## SERVICE BULLETIN

**SVR 09-004**

**Product:** Grain Belt Header, Wide Strut Swather Table and Grain Belt Plus.

**Re:** Optional Cross Auger

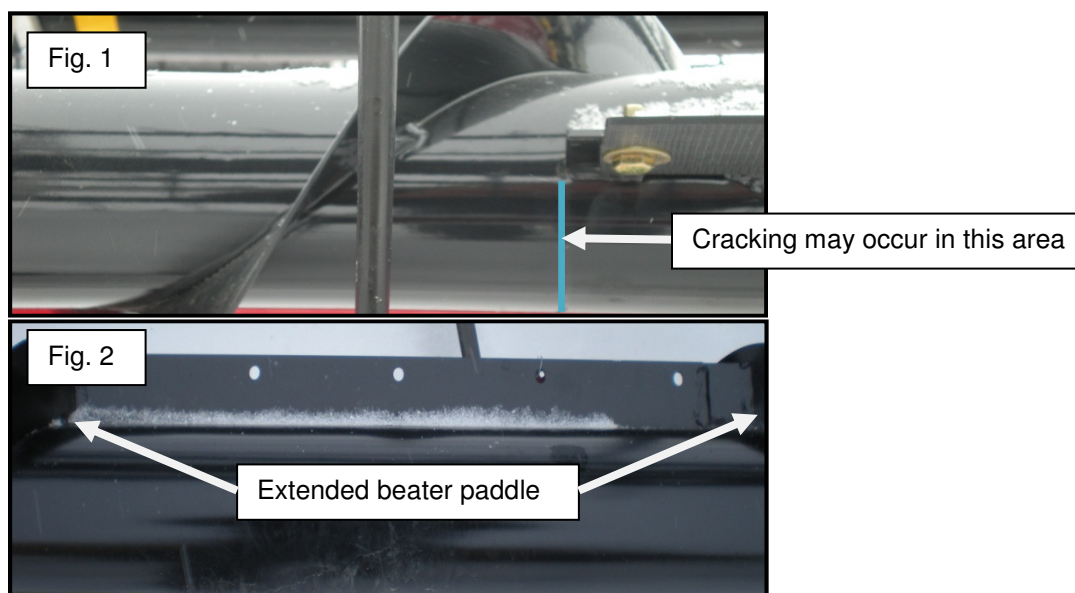
**Problem:** It has been brought to our attention that a stress crack may occur in the cross auger tubing, originating in the weld at the end of the beater paddle (*as per Fig. 1*). The beater paddle is located on the center section of the three piece cross auger. If operating continues once the crack has developed, the result will be complete auger failure.

**Solution:** Examine existing product, if damage is observed remove center auger and replace with correctly manufactured part, on which beater extends from LH flighting to RH flighting (Fig. 2).
